Southcenter Comprehensive Plan Chapter Issues Matrix

Southcenter Subarea Plan - Issues Matrix

TMC 18.28 TUC District Zoning Regulations - Revised Issues Matrix

Southcenter Design Manual Issues Matrix

A) Walking Radius for parking reduction eligibility

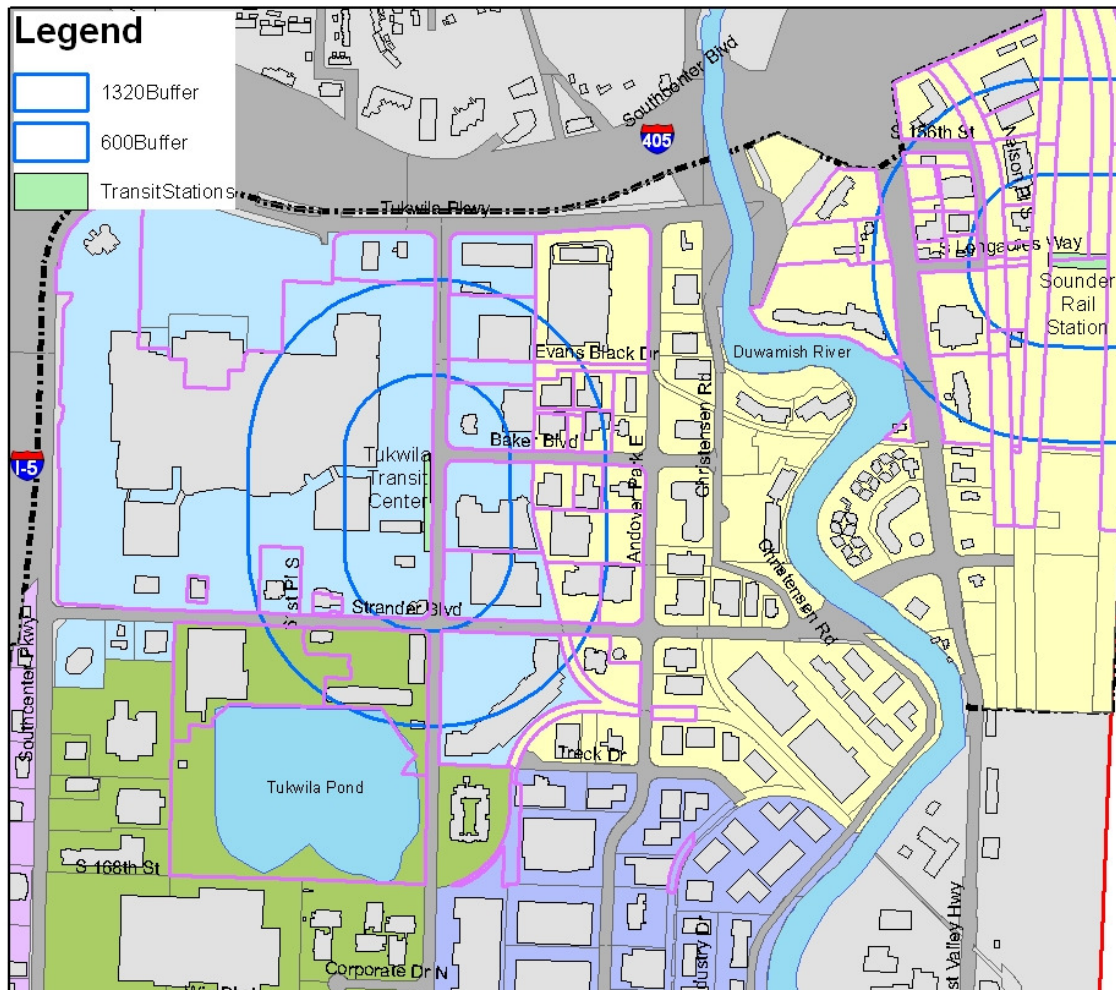
p. 59	TMC 18.28.260.B.5.b. Increase the distance a property may be from transit center in order to be eligible for a parking reduction from 600 to 1320 feet. This will allow for reduced parking requirements for residential development and encourage new housing to locate in close proximity to transit center. Studies have shown that this is the distance people will walk to commuter rail station.	Ex. 6, 7, 9; PC mtg 6/28/12, Open House; Jamie Durkin	It is almost 1/4 mile from the station to West Valley Highway so an increase would allow businesses along Longacres to apply for the reduction. The full 1/4 mile around the bus transit center would capture a large number of businesses. See illustration A for extent of 600 and 1320 foot distances from the station and transit center. Staff Recommendation: Change distance to 1320' for residential units, retain 600 for commercial uses.

p. 59	Within 1/4 mile of Sounder Station, want only 1 space required per dwelling unit.	J.Desimone	See illustration A for extent of 1320 foot distances from the station and transit center. Proposed code has already lowered parking standards to 1 per studio or 1 bedroom, 1.5 for 2 bedrooms, 2 for 3 bedrooms. Staff Recommendation: Change distance for parking exception to 1320' for residential units.
Parking Structure Incentives	What incentives can we offer for creation of structured parking? It frees up space for development, reduces polluted run-off and is visually more appealing.	Mann, Alford PC mtg 8/23/12	The ECONW technical report indicated that the type of developer incentives needed for parking structures will most likely take the form of creative financing, public/private partnerships, and/or predevelopment agreements rather than through regulatory measures. Each project will have different needs, so ECONW recommends preparing a "public sector redevelopment tool kit" that could be used to offer developers assistance in order to achieve the community's goals for the urban center. We would welcome other suggestions.

B) Information about the negative effects of tree topping

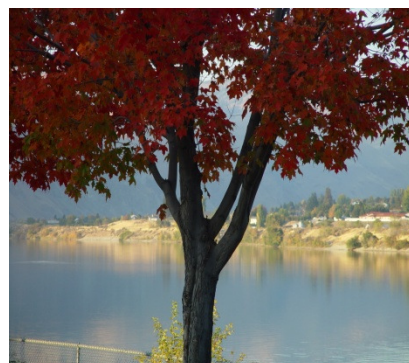
p. 44 18.28.240	It is surprising to see the City extend its retroactive reach beyond public frontage to "other areas on-premises". The language being proposed is dictating pruning regulations within a property, not just along street frontages. Depending on how the existing landscaping will tolerate the new pruning regulations, the TUC Plan could require a property owner to replace all landscaping. Additionally the TUC Plan states that existing trees may not be topped for any reason. More often than not, topping is requested/required by the retail tenant to ensure signage visibility. In retail leasing it is all about traffic counts, visibility and parking. We have tenant commitments to ensure a signage sightline from the intersection of Strander and Andover Park W. As a result we do monitor the height of trees in the parking lot area and prune where necessary. The proposed TUC Plan assumes buildings are constructed immediately adjacent to the road where signage visibility would not be impacted by any trees. Most of the existing strip centers are set back where internal parking lot trees, could, and do, impact signage. We agree with the City's goal that care should be taken to preserve the integrity and visual appearance of existing trees, however retail tenants rely on signage and frontage and oftentimes this will drive site selection.	Ex. 11; 8/23/12; Balint for Segale	The intent is that if landscaping is planted anywhere on site it should survive, not create unsafe conditions (blind corners, harbor criminal activity, falling limbs), and provide screening where needed. Conflict between signage and trees, leading to the temptation to top them, was one of the reasons the new sign code only allows monument signs. Topping is counter-productive according to the Washington State Department of Natural Resources, resulting in dense growth of weakly attached suckers, vulnerability to insect infestation and fungal decay, which requires ongoing removal of hazardous limbs, see illustration B . This is why the current code already prohibits tree topping, 18.52.050 B. Staff Recommendation: No Change

C) Screen shot of City of Tukwila web site showing where to download the EconW Technical Memorandum.

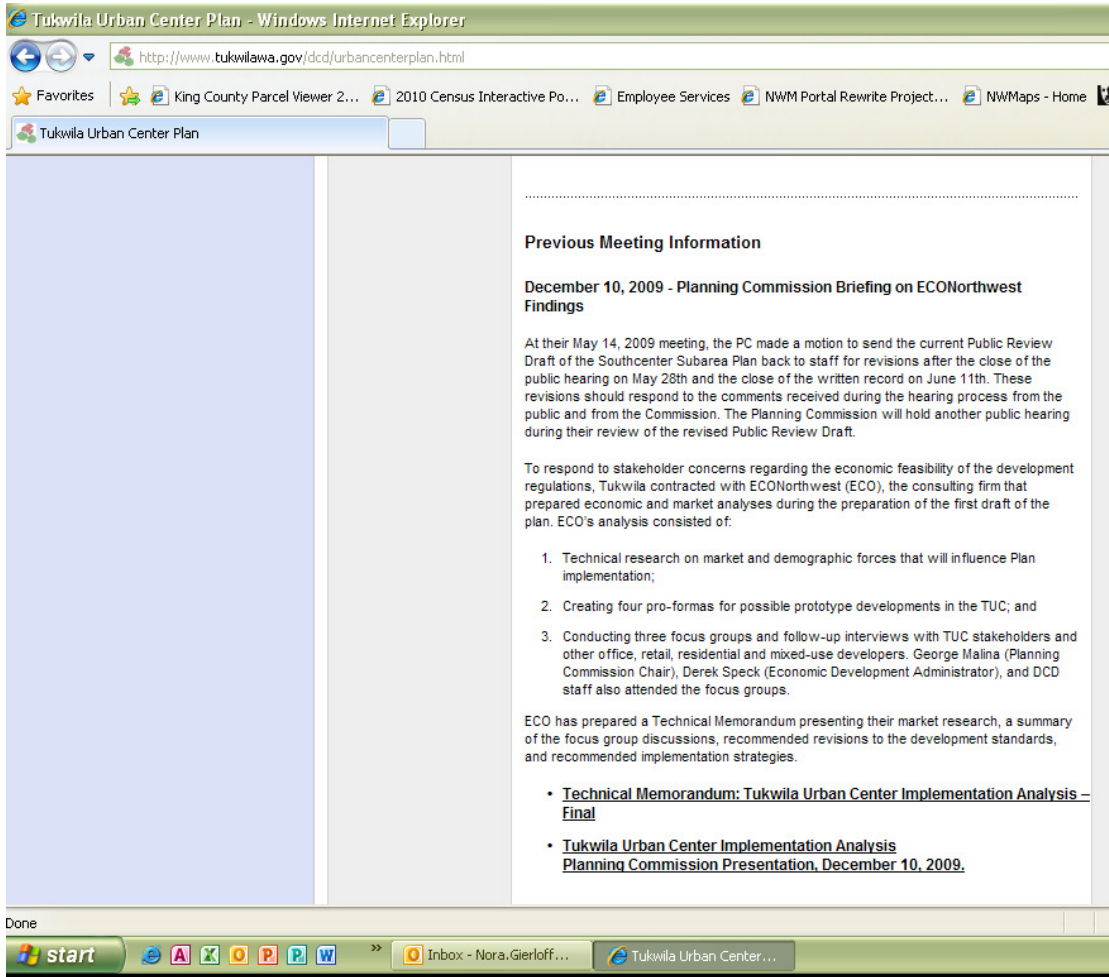
EcoNW Memo	Is the ECONorthwest document on the City's website? Will ECONorthwest prepare an analysis on this version of the Southcenter Subarea Plan?	Strander 9/10/12 Email	The EcoNW memo has been available on the City's web site since it was presented to the PC on 12/10/09, see illustration C . Staff revised the current draft of the Plan to address the changes to the development code recommended in Section 4.1 of the 2009 memo.
EcoNW Memo	The City hired EcoNW to evaluate the City's vision and the development regulations in the 2009 draft of the Plan. This memorandum is attached as it is no longer available on the City's website. EcoNW concluded that the Plan and development code require a type of development that is not financially viable at this time because of uncertainty in the financial market, and is more likely to be viable even upon the market's return with significant public investment in amenity and infrastructure. Some other key points include: - Stakeholder concerns that the building types were too expensive for Tukwila's market were realistic and TUC regulations are likely to discourage improvements to existing structures	Ex. 11; 8/23/12; Balint for Segale	The EcoNW memo has been available on the City's web site since it was presented to the PC on 12/10/09, see illustration C . Staff listened carefully to the feedback from the 3 focus groups and Eco's evaluation and made extensive changes to the Plan.
